Application for Licence

Licence Number	L7084/1997/17
Applicant	Shire of Donnybrook Balingup
File number	DER2015/001439-1
Premises	Donnybrook Waste Management Facility Goodwood Road PAYNE DALE WA 6239 Being Portion of State Forest 27 as depicted in Schedule 1 of the licence
Date of report	16 September 2024
Decision	Licence granted

Figure 2: Residential and sensitive receptors in relation to the prescribed premises

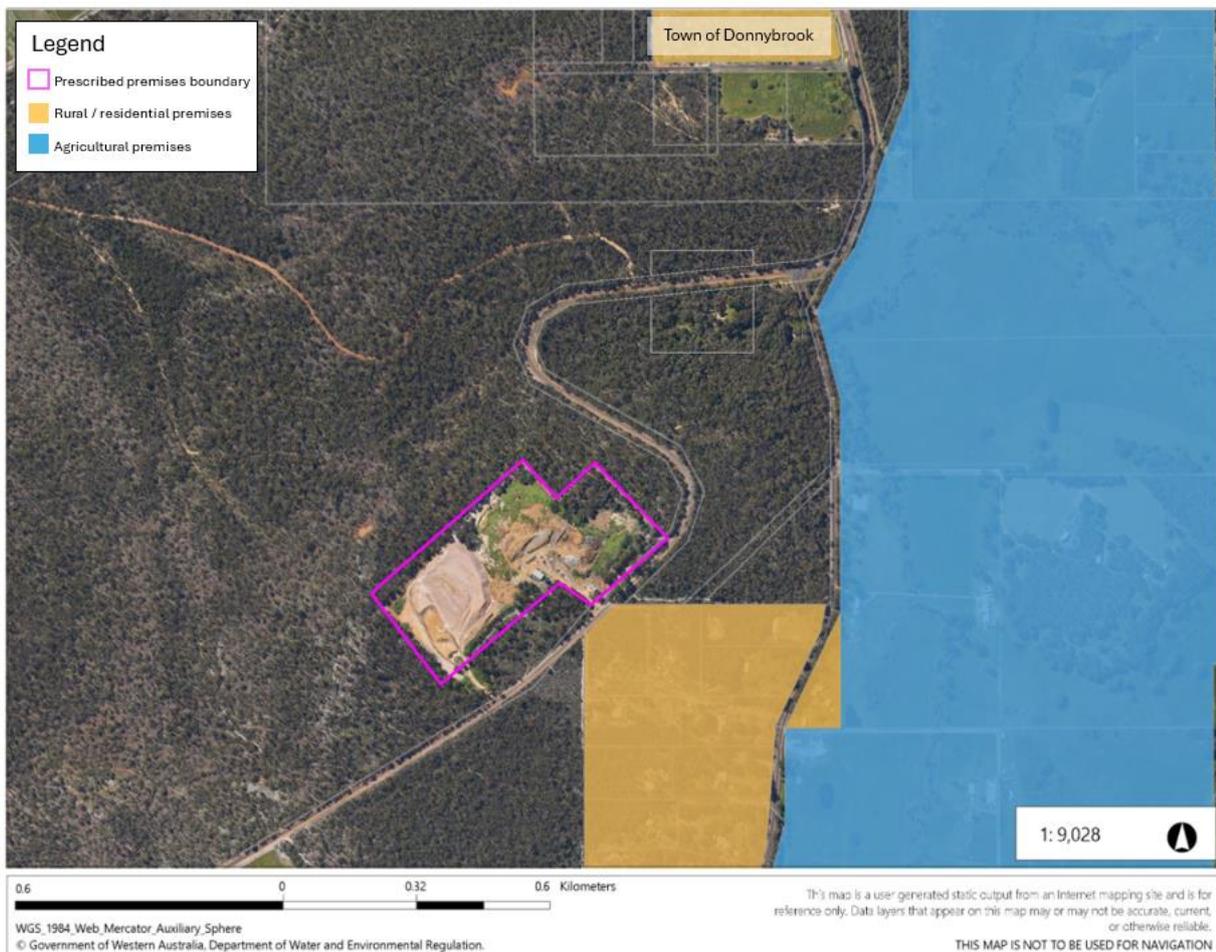
Condition	Summary of applicant's comment	Department's response
Decision report – Figure 2	Figure 2 – the “rural/residential premises” marked in red below is the Shire Pound (located within a Crown Reserve) so likely not considered a sensitive receptor with relation to the landfill.	Noted. The figure has been updated to remove the Shire Pound as a receptor.
Decision report – Figure 7	As discussed, the Shire has met with the site contractor to discuss the proposed conditions. In an effort to better achieve compliance with respect to daily cover and windblown waste control, Shire officers have prepared a report to Council to consider changing the site operation hours to better align with the municipal waste collection drop off. This may result in a change to the site operations as outlined in Figure 7, but will still be well within the proposed operating hours as contained in proposed condition 3.	Noted. The reference to opening hours in the Operational Overview has been removed to avoid future confusion if operational hours are changed.
